Town of Parker
SALISBURY PARK NORTH - PHASE 1
11700 MOTSENBOCKER RD
PARKER, CO 80134

PHASE 1 DETAILED GRADING & DRAINAGE PLAN

SITE PLAN SUBMITTAL
Page 51 of 311

PHASE 1 STORM PLAN & PROFILE

STORM BYPASS PROFILE
SCALE: 1" = 20' HORIZ
1" = 5' VERT

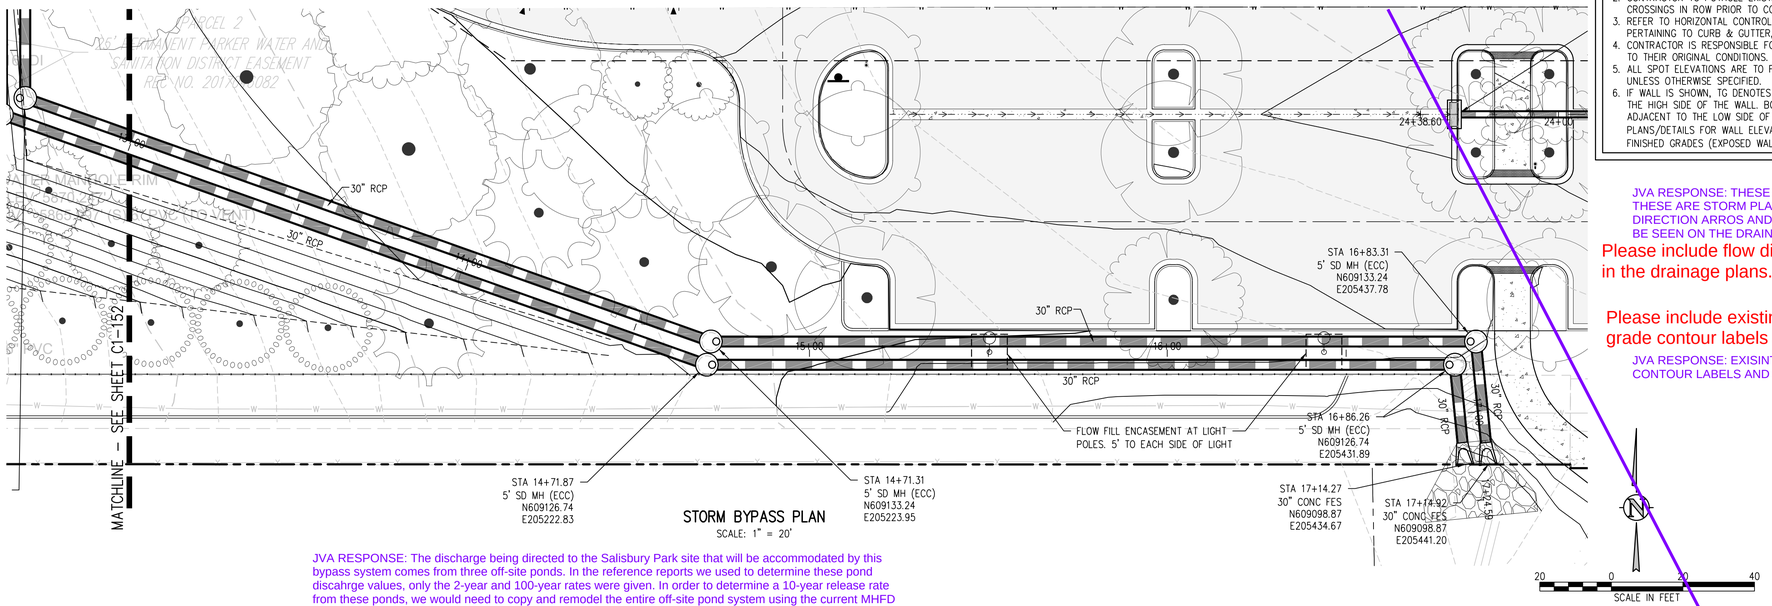
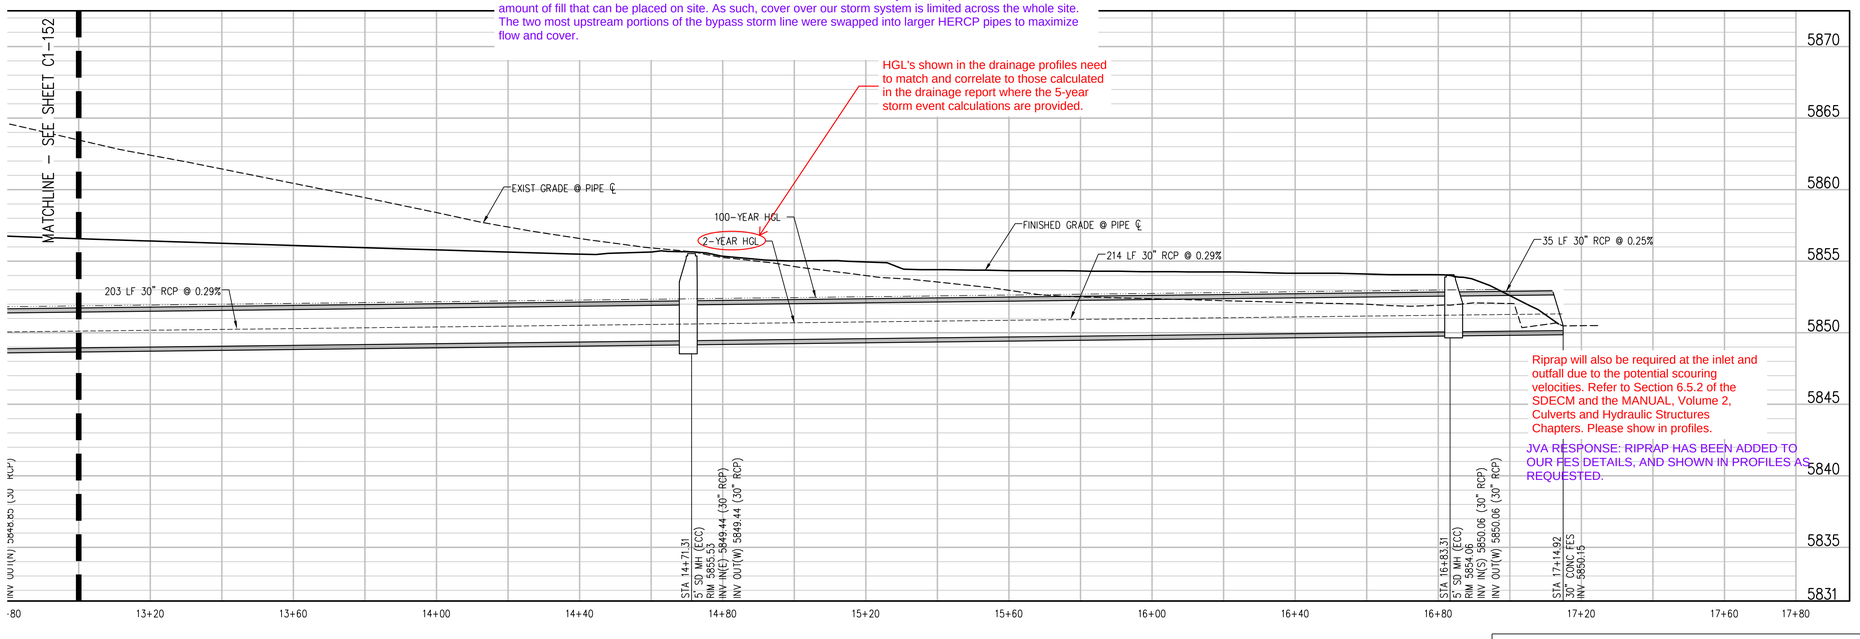
Please include a Key Map for maps that consist of plan views showing a portion of the overall site

Please include flow direction arrows and a legend in the drainage plans.

HGL's shown in the drainage profiles need to match and correlate to those calculated in the drainage report where the 5-year storm event calculations are provided.

Riprap will also be required at the inlet and outfall due to the potential scouring velocities. Refer to Section 6.5.2 of the SDECM and the MANUAL, Volume 2, Culverts and Hydraulic Structures Chapters. Please show in profiles.

JVA RESPONSE: KEY MAP CAN BE SEEN IN THE BOTTOM OF THE TITLE BLOCK

JVA RESPONSE: THESE AREN'T DRAINAGE PLANS, THESE ARE STORM PLAN AND PROFILES. FLOW DIRECTION ARROS AND DRAINAGE LEGEND CAN BE SEEN ON THE DRAINAGE PLANS.

JVA RESPONSE: EXISINTG AND PROPOSED GRADE CONTOUR LABELS AND SLOPES ADDED.

JVA RESPONSE: The discharge being directed to the Salisbury Park site that will be accommodated by this bypass system comes from three off-site ponds. In the reference reports we used to determine these pond discahrge values, only the 2-year and 100-year rates were given. In order to determine a 10-year release rate from these ponds, we would need to copy and remodel the entire off-site pond system using the current MHFD detention spreadsheets. Additionally, section 6.4.2 of the Parker SDECM for Culvert Sizing Criteria references street ovetopping for the 100 and 10-yr design storm as being the controlling factor. Our SWMM model for this system was run using the 100-year storm event. The results of the model indicate that no street overtopping will occur during this storm event. For most of the storm line, the 100-year HGL falls within the crown of the pipes. This result indicates that a 10-year storm event would be completely contained within the storm system. Lastly, as mentioned in our variance section, due to the sites location within a 100-year floodplain, we are limited to the amount of fill that can be placed on site. As such, cover over our storm system is limited across the whole site. The two most upstream portions of the bypass storm line were swapped into larger HERCP pipes to maximize flow and cover.

JVA RESPONSE: RIPRAP HAS BEEN ADDED TO OUR FES DETAILS, AND SHOWN IN PROFILES AS REQUESTED.

STORM LINE A PLAN
SCALE: 1" = 20'

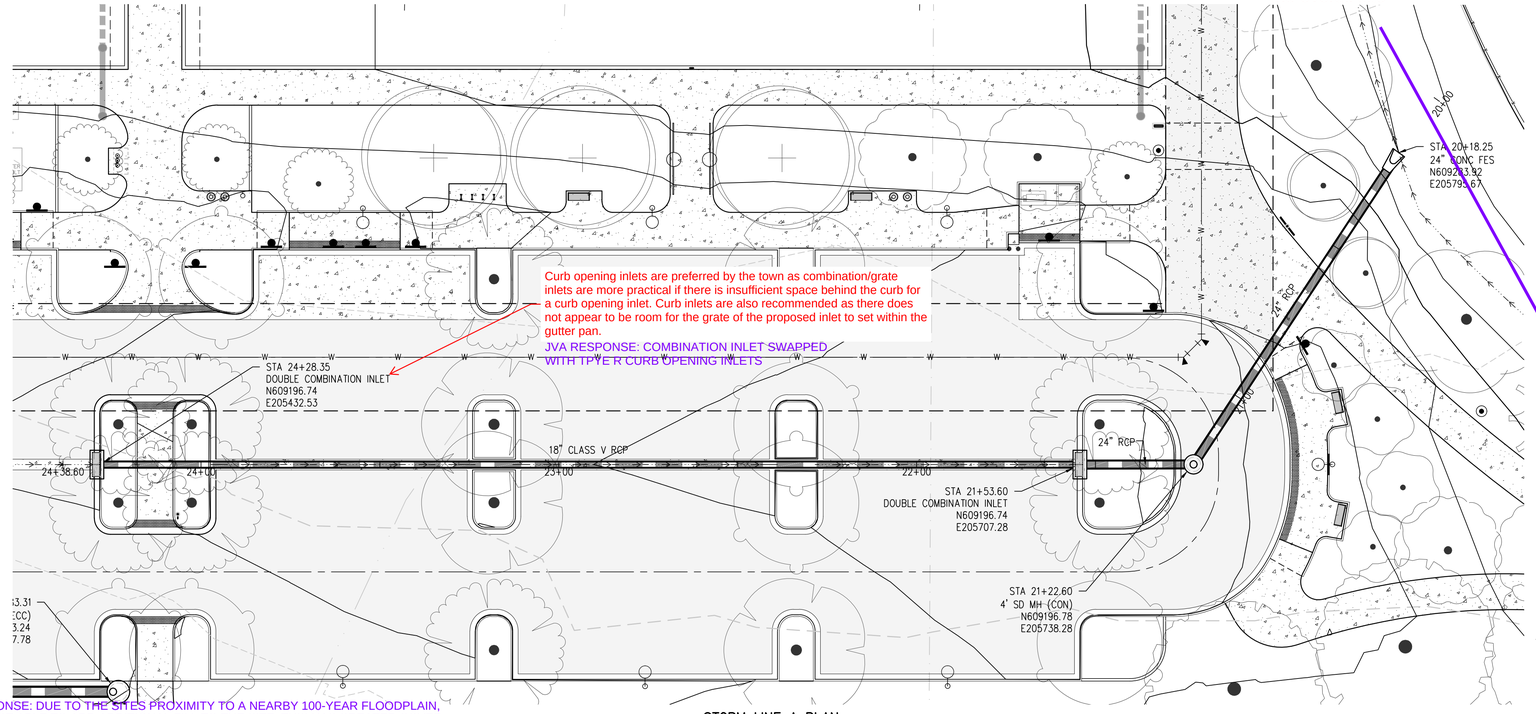
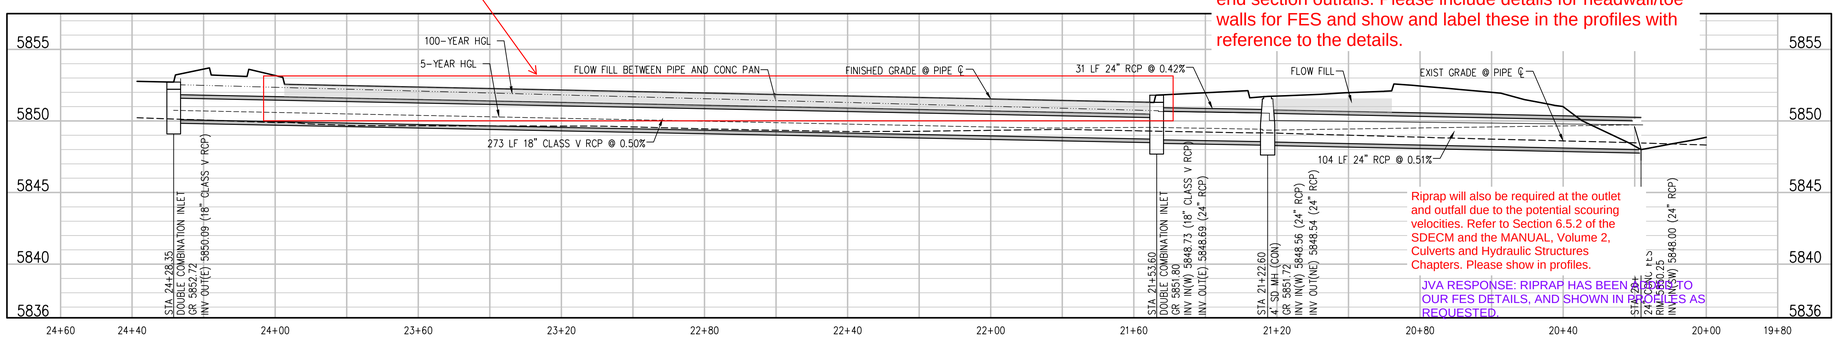
Please include a Key Map for maps that consist of plan views showing a portion of the overall site

Please include flow direction arrows and a legend in the drainage plans.

Please label Inlet IDs in the construction documents that clearly correlate to labels shown in the proposed basin maps and inlet calculations of the drainage report. (TYP)

Joint restraints and toe-walls, conforming to CDOT M&S Standard Plan No. M-601-11 shall be used on all RCP flared end section outfalls. Please include details for headwall/toe walls for FES and show and label these in the profiles with reference to the details.

Riprap will also be required at the outlet and outfall due to the potential scouring velocities. Refer to Section 6.5.2 of the SDECM and the MANUAL, Volume 2, Culverts and Hydraulic Structures Chapters. Please show in profiles.

JVA RESPONSE: KEY MAP CAN BE SEEN IN THE BOTTOM OF THE TITLE BLOCK

JVA RESPONSE THESE ARENT DRAINAGE PLANS. THESE ARE STORM PLAN AND PROFILES. FLOW DIRECTION ARROWS AND DRAINAGE LEGEND CAN BE SEEN ON THE DRAINAGE P[LANS.

JVA RESPONSE: EXISINTG AND PROPOSED GRADE CONTOUR LABELS AND SLOPES ADDED.

JVA RESPONSE: DUE TO THE SITES PROXIMITY TO A NEARBY 100-YEAR FLOODPLAIN, WE ARE NOT ABLE TO ADD ADDITIONAL FILL TO THE SITE. THIS HAS CREATED COVER ISSUES FOR MANY STORM PIPES ACROSS THE SITE. BECUASE OF THIS, WE ARE UNABLE TO INCREASE THE SLOPE OR SIZE OF ANY OF THE STORM LINES SHOWN, WHICH MEANS WE ARE UNABLE TO ACCOMIDATE THIS CODE REQUIREMENT. A VARIANCE REQUEST HAS BEEN ADDED TO THE DRAINAGE REPORT TO THIS EFFECT.

Inlet ID labels have been added to the stormwater plans.

JVA RESPONSE: TOE-WALLS CONFORMING TO CDOT M&S STANDARD PLAN NO. M-601-11 HAVE BEEN ADDED TO OUR FES DETAIL AND SHOWN AS REQUESTED ON PLANS.

JVA RESPONSE: RIPRAP HAS BEEN ADDED TO OUR FES DETAILS, AND SHOWN IN PLANS AS REQUESTED.

STORM LINE B PLAN
SCALE: 1" = 20'

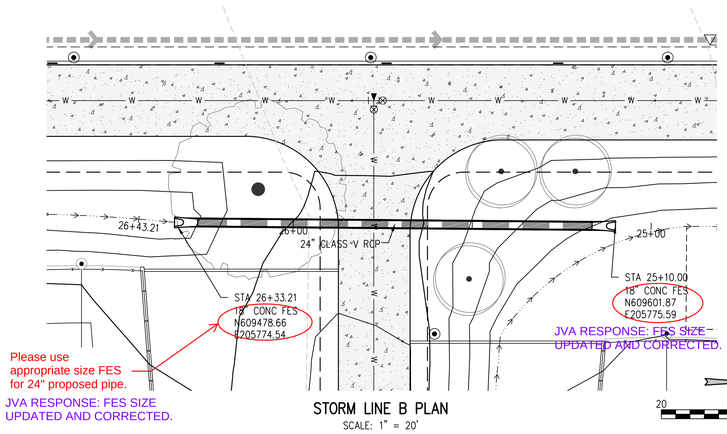
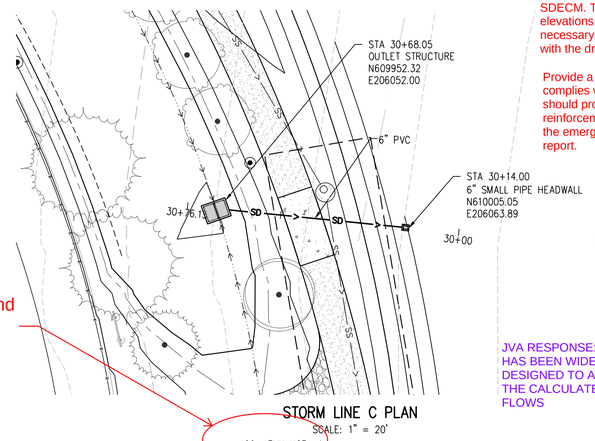
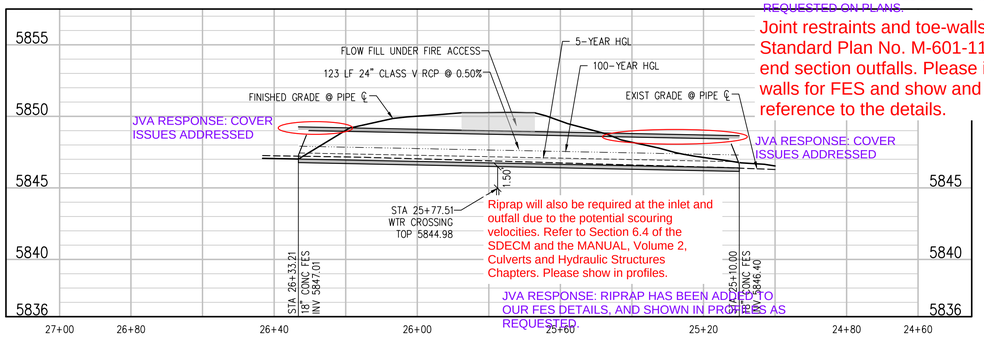
Please include a Key Map for maps that consist of plan views showing a portion of the overall site

Please reference appropriate details throughout the plans. (TYP)

Please include flow direction arrows and a legend in the drainage plans.

Please include existing and proposed grade contour labels and slopes. (TYP)

Reference and provide a detail for the pond outlet control structure which complies with Figures 7.5 or 7.9 of the Town's SDECM. The detail should provide a minimum of all dimensions, elevations, material, reinforcement, and any other information necessary to construct the outlet control structure in compliance with the drainage report.

Provide a detail for the pond emergency overflow spillway which complies with Figure 7.6 of the Town's SDECM. The detail should provide a minimum of all dimensions, elevations, material, reinforcement, and any other information necessary to construct the emergency overflow spillway in compliance with the drainage report.

Please use appropriate size FES for 24" proposed pipe.

Please adjust overlapping labels and ensure labels are readable/visible throughout the plans. (TYP)

Joint restraints and toe-walls, conforming to CDOT M&S Standard Plan No. M-601-11 shall be used on all RCP flared end section outfalls. Please include details for headwall/toe walls for FES and show and label these in the profiles with reference to the details.

Riprap will also be required at the inlet and outfall due to the potential scouring velocities. Refer to Section 6.4 of the SDECM and the MANUAL, Volume 2, Culverts and Hydraulic Structures Chapters. Please show in profiles.

JVA RESPONSE: KEY MAP CAN BE SEEN IN THE BOTTOM OF THE TITLE BLOCK

JVA RESPONSE: REFERENCES TO DETAILS HAVE BEEN ADDED TO SHEETS.

JVA RESPONSE: THESE AREN'T DRAINAGE PLANS, THESE ARE STORM PLAN AND PROFILES. FLOW DIRECTION ARROWS AND DRAINAGE LEGEND CAN BE SEEN ON THE DRAINAGE P[LANS.

JVA RESPONSE: EXISINTG AND PROPOSED GRADE CONTOUR LABELS AND SLOPES ADDED.

JVA RESPONSE: DETAILS FOR THE POND OUTLET CONTROL STRUCTURES HAVE BEEN CREATED AND CALLED OUT ACCORDINGLY ON SHEET C1-116.

JVA RESPONSE: A DETAIL FOR THE POND EMERGENCY OVERFLOW SPILLWAY HAS BEEN CALLED OUT ON SHEET C1-116.

JVA RESPONSE: FES SIZE UPDATED AND CORRECTED.

JVA RESPONSE: FES SIZE UPDATED AND CORRECTED.

JVA RESPONSE: LABEL POSITIONING HAS BEEN UPDATED

JVA RESPONSE: SPILLWAY HAS BEEN WIDENED AND DESIGNED TO ACCOMIDATE THE CALCULATED DESIGN FLOWS

JVA RESPONSE: TOE-WALLS CONFORMING TO CDOT M&S STANDARD PLAN NO. M-601-11 HAVE BEEN ADDED TO OUR FES DETAIL AND SHOWN AS ~~REQUESTED ON PLANS~~.

JVA RESPONSE: COVER ISSUES ADDRESSED

JVA RESPONSE: COVER ISSUES ADDRESSED

JVA RESPONSE: RIPRAP HAS BEEN ADDED TO OUR FES DETAILS, AND SHOWN IN PROFILES AS REQUESTED.

STORM LINE D PLAN
SCALE: 1" = 20'

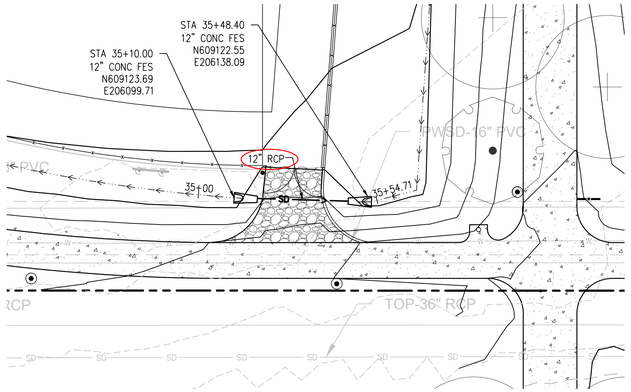
Please include a Key Map for maps that consist of plan views showing a portion of the overall site

Please include flow direction arrows and a legend in the drainage plans.

Joint restraints and toe-walls, conforming to CDOT M&S Standard Plan No. M-601-11 shall be used on all RCP flared end section outfalls. Please include details for headwall/toe walls for FES and show and label these in the profiles with reference to the details.

Riprap will also be required at the inlet and outfall due to the potential scouring velocities. Refer to Section 6.4 of the SDECM and the MANUAL, Volume 2, Culverts and Hydraulic Structures Chapters. Please show in profiles.

JVA RESPONSE: KEY MAP CAN BE SEEN IN THE BOTTOM OF THE TITLE BLOCK

JVA RESPONSE: THESE AREN'T DRAINAGE PLANS, THESE ARE STORM PLAN AND PROFILES. FLOW DIRECTION ARROWS AND DRAINAGE LEGEND CAN BE SEEN ON THE DRAINAGE P[LANS.

JVA RESPONSE: EXISINTG AND PROPOSED GRADE CONTOUR LABELS AND SLOPES ADDED.

JVA RESPONSE: DUE TO THE SITES PROXIMITY TO A NEARBY 100-YEAR FLOODPLAIN, WE ARE NOT ABLE TO ADD ADDITIONAL FILL TO THE SITE. THIS HAS CREATED COVER ISSUES FOR MANY STORM PIPES ACROSS THE SITE. BECUASE OF THIS, WE ARE UNABLE TO INCREASE THE SLOPE OR SIZE OF ANY OF THE STORM LINES SHOWN, WHICH MEANS WE ARE UNABLE TO ACCOMIDATE THIS CODE REQUIREMENT. A VARIANCE REQUEST HAS BEEN ADDED TO THE DRAINAGE REPORT TO THIS EFFECT.

JVA RESPONSE: CODE ISSUES ADDRESSED

JVA RESPONSE: RIPRAP HAS BEEN ADDED TO OUR FES DETAILS, AND SHOWN IN PROFILES AS REQUESTED.

STORM LINE F PROFILE
SCALE: 1"=20' HORIZ
1"=5' VERT

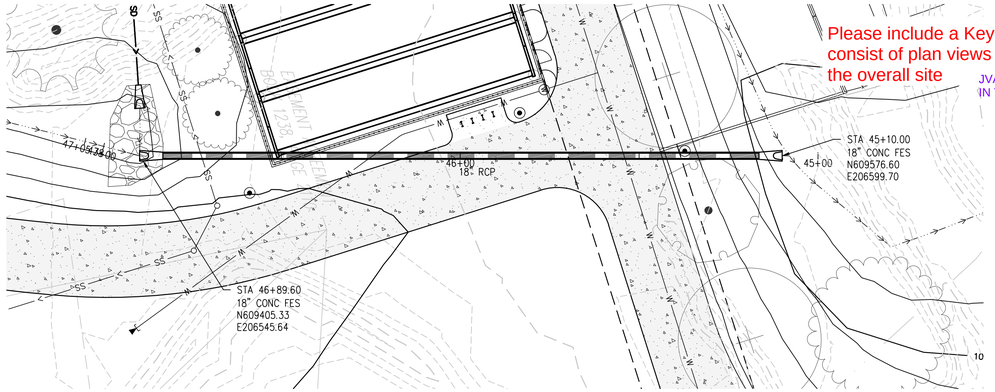
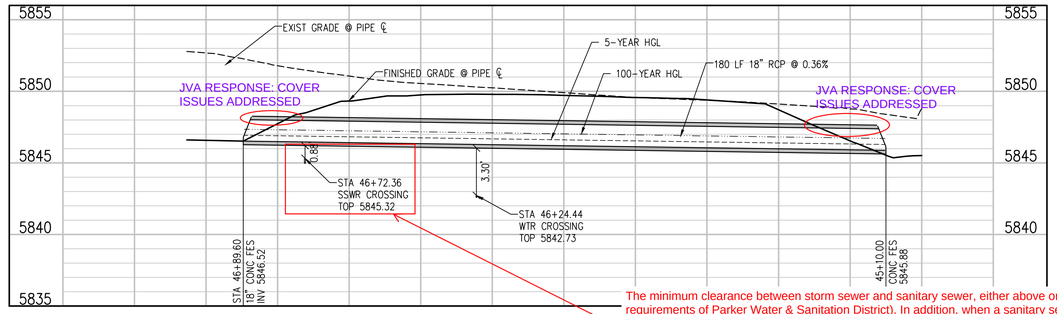
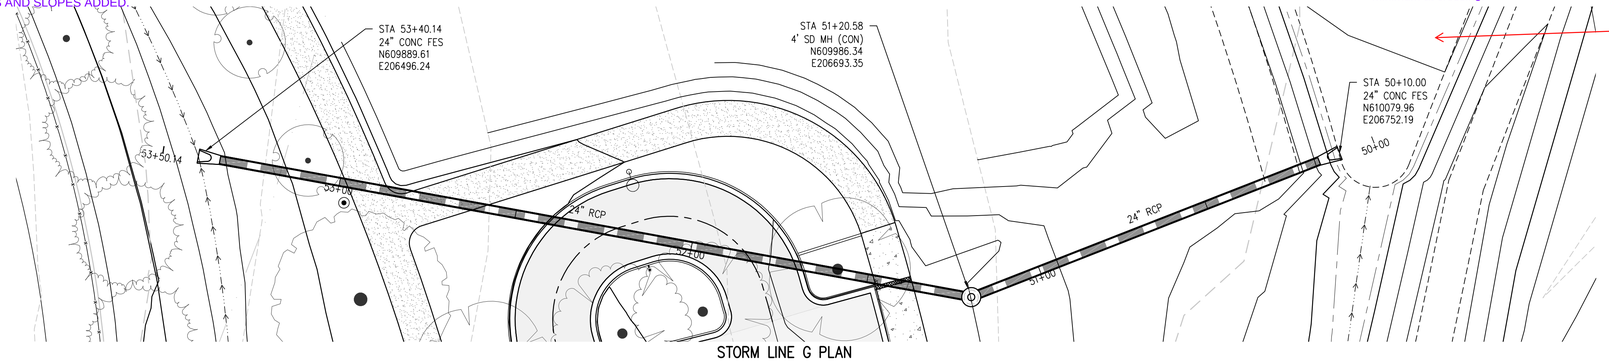
Please include flow direction arrows and a legend in the drainage plans.

Please include a Key Map for maps that consist of plan views showing a portion of the overall site

Joint restraints and toe-walls, conforming to CDOT M&S Standard Plan No. M-601-11 shall be used on all RCP flared end section outfalls. Please include details for headwall/toe walls for FES and show and label these in the profiles with reference to the details.

The minimum clearance between storm sewer and sanitary sewer, either above or below, shall also be 18 inches (per requirements of Parker Water & Sanitation District). In addition, when a sanitary sewer main lies above a storm sewer, or within 18 inches below, the sanitary sewer shall have an impervious encasement or be constructed of mortar lined ductile iron pipe for a minimum of ten feet on each side of where the storm sewer crosses. Clearances less than 18 inches shall require the approval of the applicable water & sanitation district and the Public Works Department.

JVA RESPONSE: THESE AREN'T DRAINAGE PLANS, THESE ARE STORM PLAN AND PROFILES. FLOW DIRECTION ARROWS AND DRAINAGE LEGEND CAN BE SEEN ON THE DRAINAGE P[LANS.

JVA RESPONSE: EXISINTG AND PROPOSED GRADE CONTOUR LABELS AND SLOPES ADDED.

JVA RESPONSE: KEY MAP CAN BE SEEN IN THE BOTTOM OF THE TITLE BLOCK

Vertical clearance has been adjusted to provide 18" minimum at crossing.

JVA RESPONSE: THESE AREN'T DRAINAGE PLANS, THESE ARE STORM PLAN AND PROFILES. FLOW DIRECTION ARROWS AND DRAINAGE LEGEND CAN BE SEEN ON THE DRAINAGE P[LANS.

STORM LINE G PROFILE
SCALE: 1"=20' HORIZ
1"=5' VERT

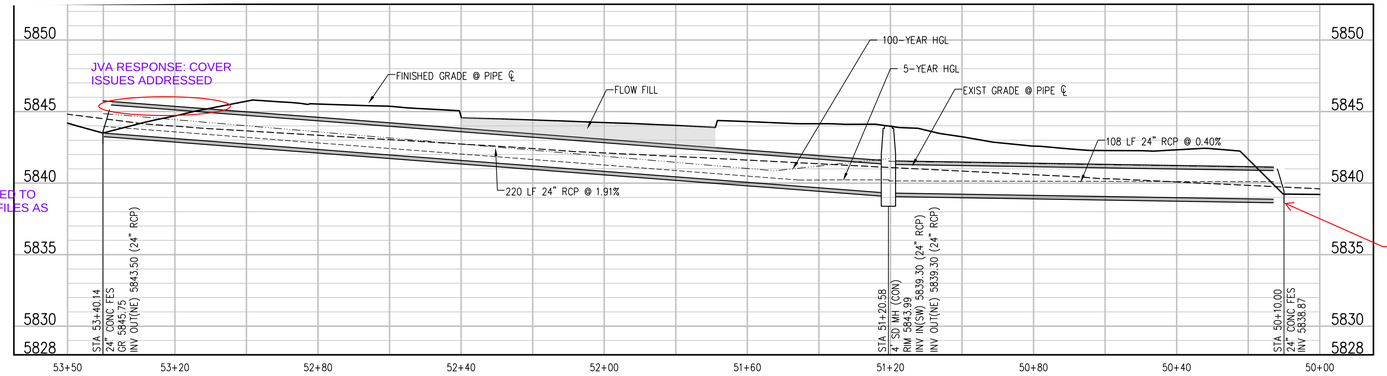
Riprap will also be required at the inlet and outfall due to the potential scouring velocities. Refer to Section 6.4 of the SDECM and the MANUAL, Volume 2, Culverts and Hydraulic Structures Chapters. Please show in profiles.

JVA RESPONSE: RIPRAP HAS BEEN ADDED TO OUR FES DETAILS, AND SHOWN IN PROFILES AS REQUESTED.

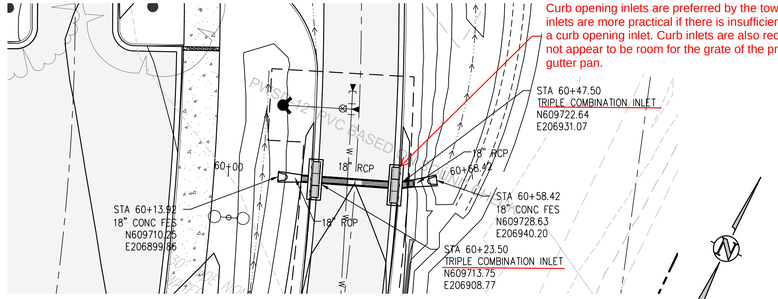
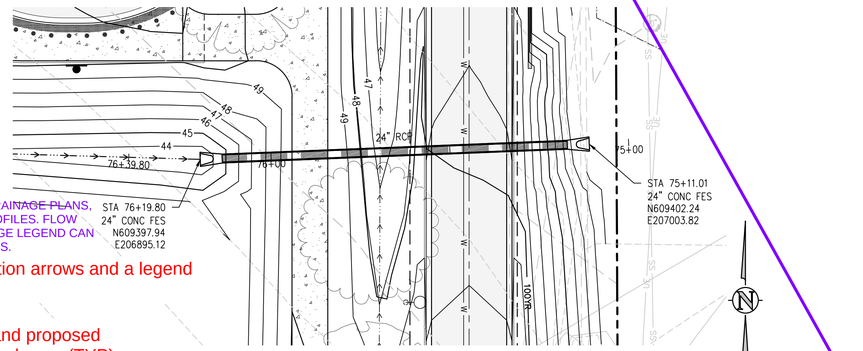
Please include a Key Map for maps that consist of plan views showing a portion of the overall site

Please include flow direction arrows and a legend in the drainage plans.

JVA RESPONSE: KEY MAP CAN BE SEEN IN THE BOTTOM OF THE TITLE BLOCK

JVA RESPONSE: THESE AREN'T DRAINAGE PLANS. THESE ARE STORM PLAN AND PROFILES. FLOW DIRECTION ARROWS AND DRAINAGE LEGEND CAN BE SEEN ON THE DRAINAGE P[LANS.
